42iQ Series pump

The purpose of this technical bulletin is to provide information related to the introduction of a new internal pump for the 42iQ series of NOx analyzers.

Image of new pump installed in 42iQ

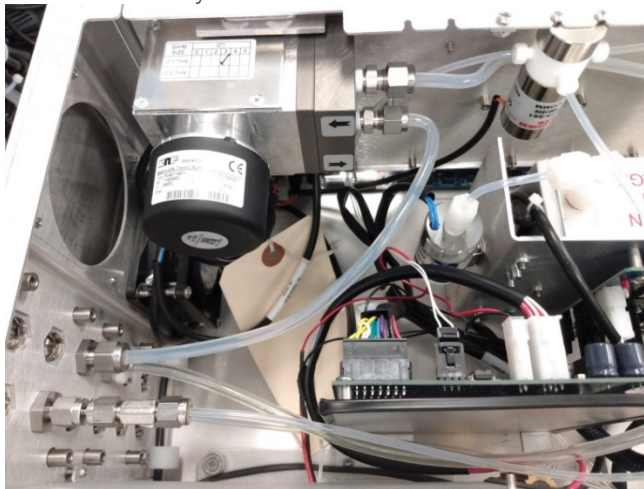
This new internal pump will be used in the models 42iQ, 42iQD, 42iQLS and 42iQHL (with bypass option).

The new pump is the same form, fit and function and meets all Thermo Scientific specifications and applicable certifications to be used in the above listed 42iQ series of NOx analyzers.

- Customers replacing the existing double headed KNF DC pump use part number **120858-00 (Retro-fit kit)** as this will include the new pump, bulkhead fitting, Teflon tubing and installation instructions.
- If your 42iQ has shipped with or has been converted to this new pump and a replacement is needed, please order part number **120442-00 (Pump only)**.
